Staff Report Addendum

Date: October 3, 2025
To: Douglas County Planning Commission
From: Trevor Bedford, AICP, Senior Planner *TB*
Jeanette Bare, AICP, Planning Manager *SK for JB*
Steven E. Koster, AICP, Assistant Director of Planning Services *SK*
Subject: River Canyon Filing 2, 3rd Amendment, Lot 2A-1
Project File: LE2025-018

Project Name: River Canyon Filing 2, 3rd Amendment, Lot 2A-1

Project File #: LE2025-018

Title
OUTLET STRUCTURE
MODIFICATION DETAILS

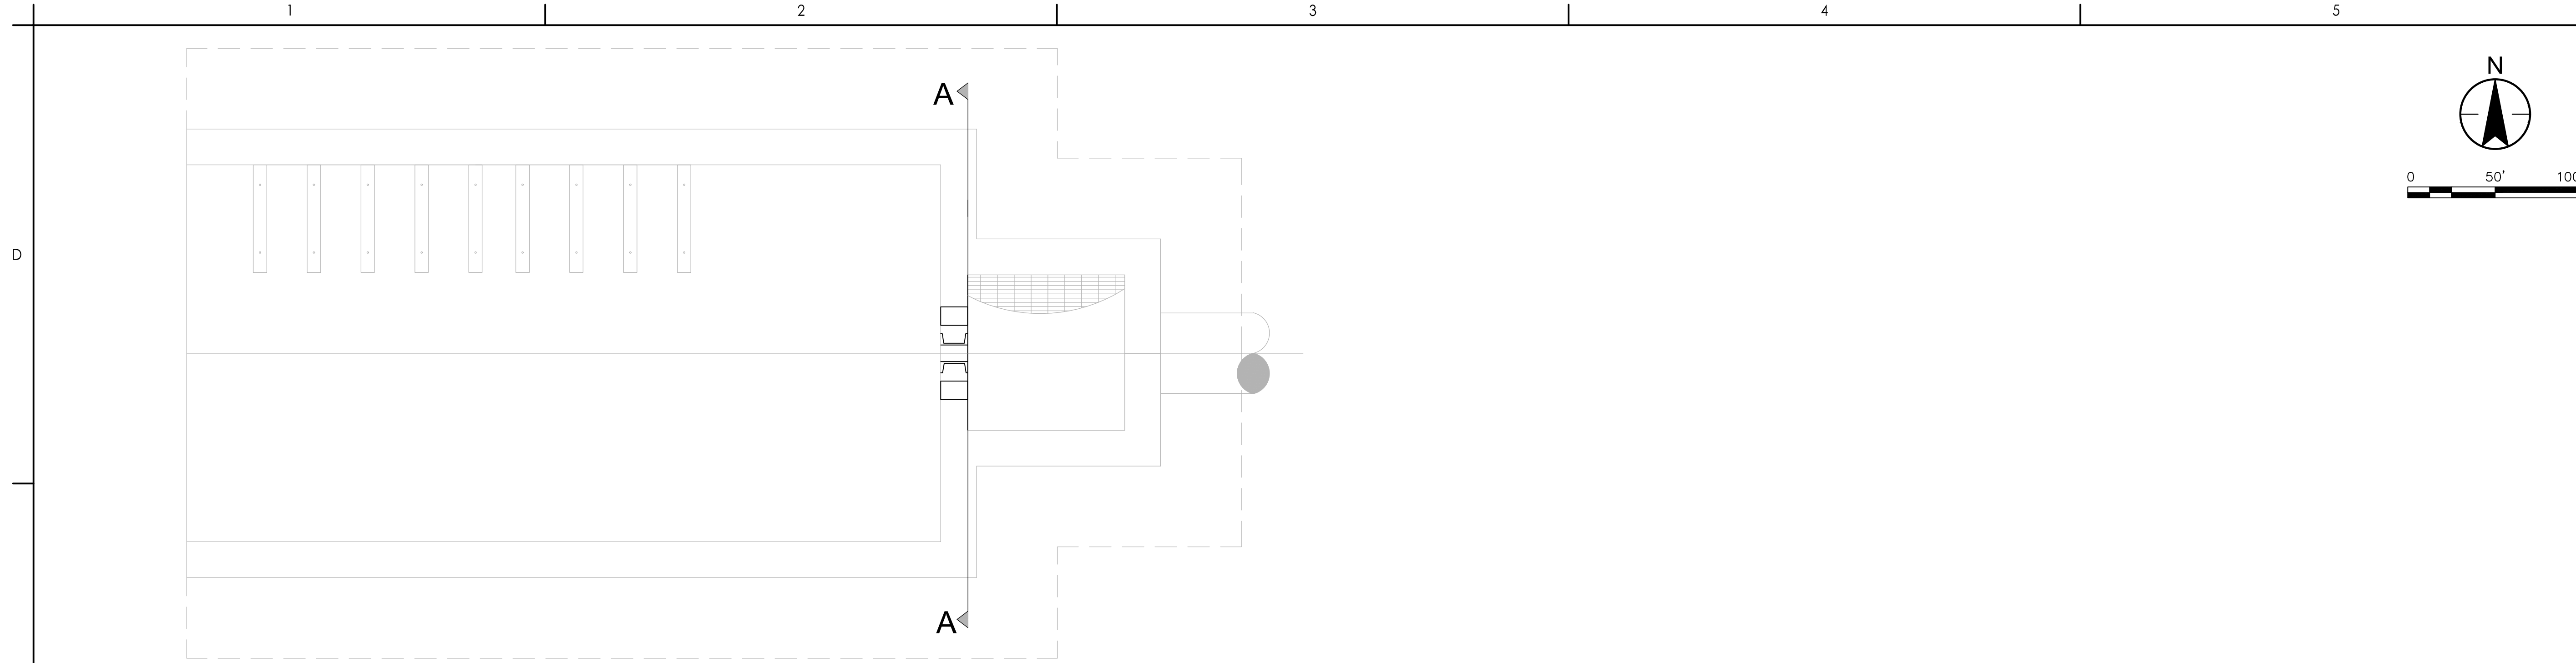
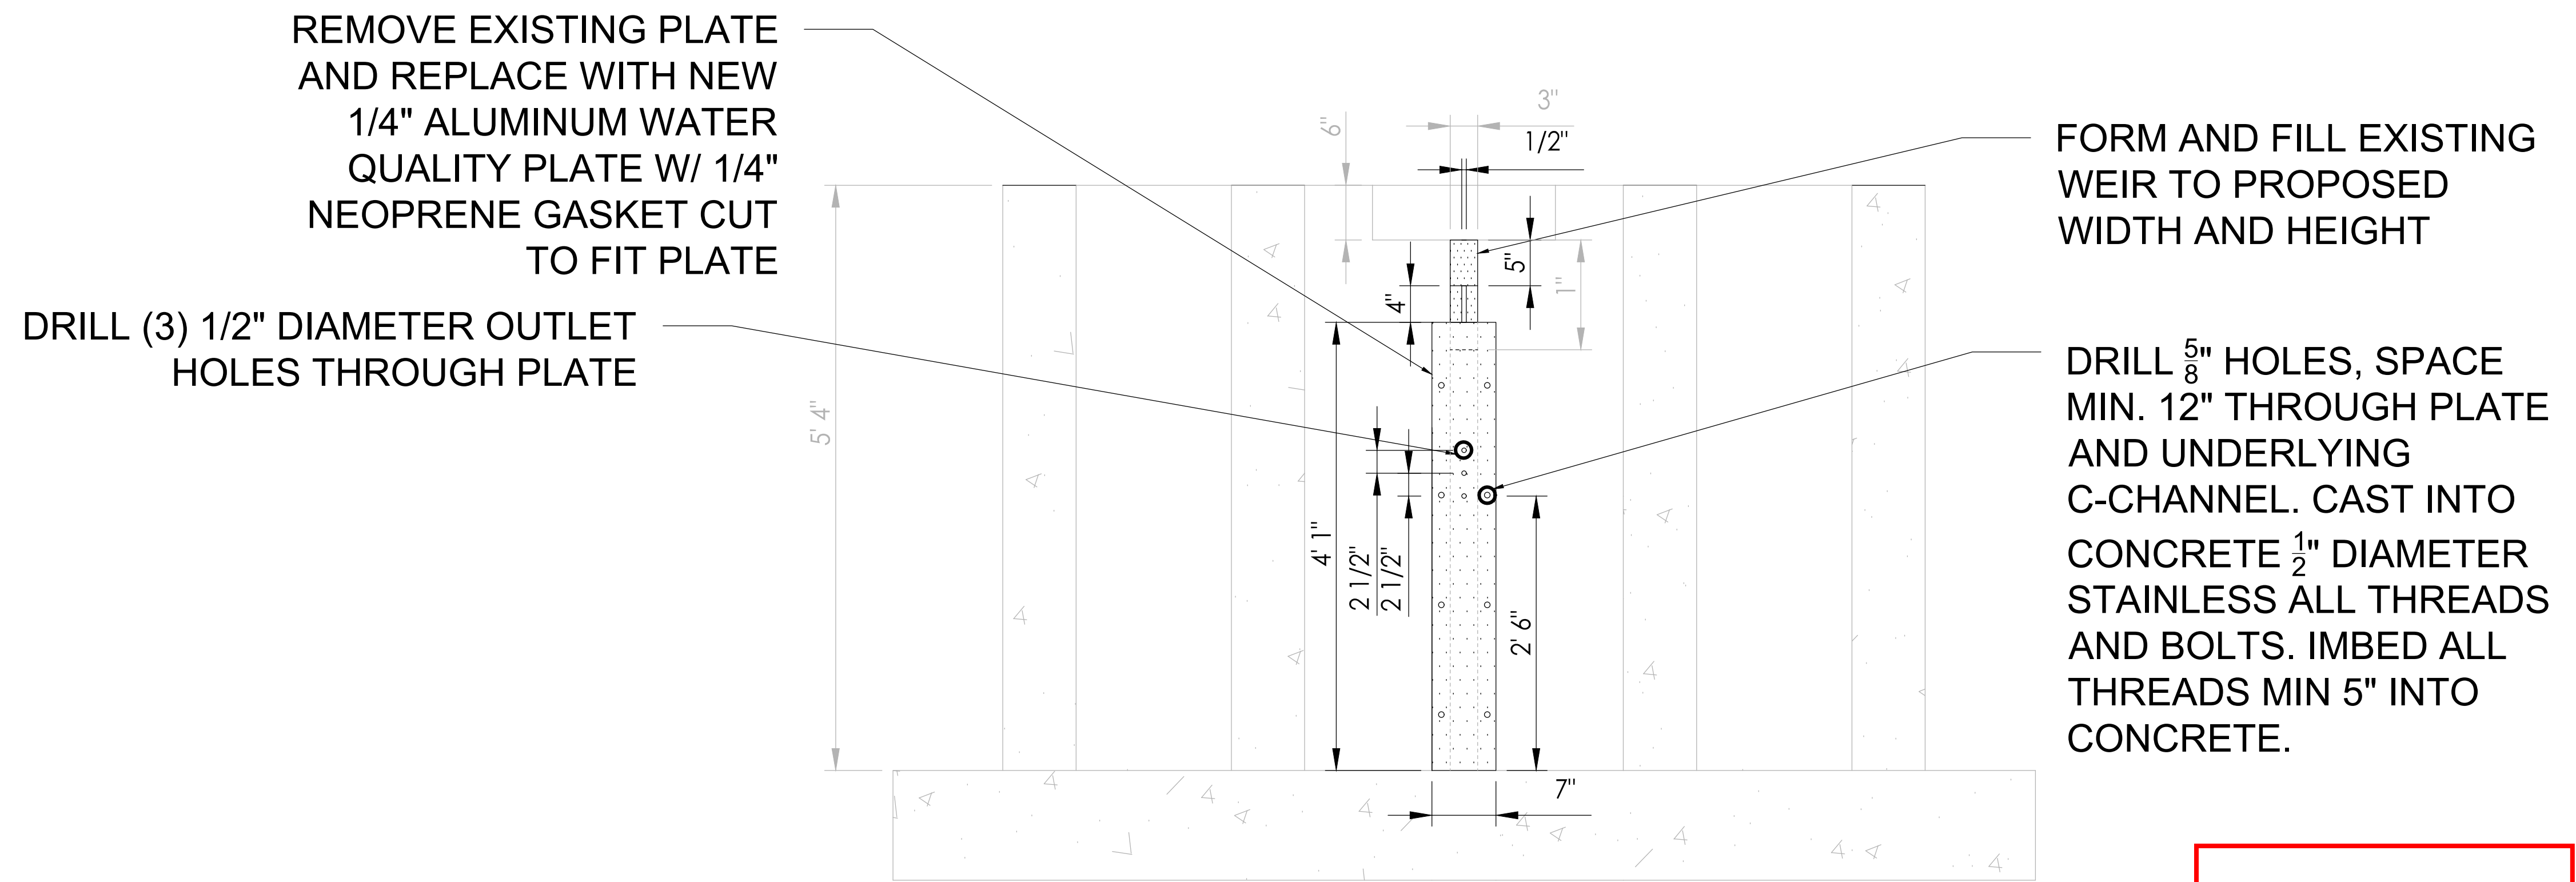
Add the Douglas
County Acceptance
Block to this sheet
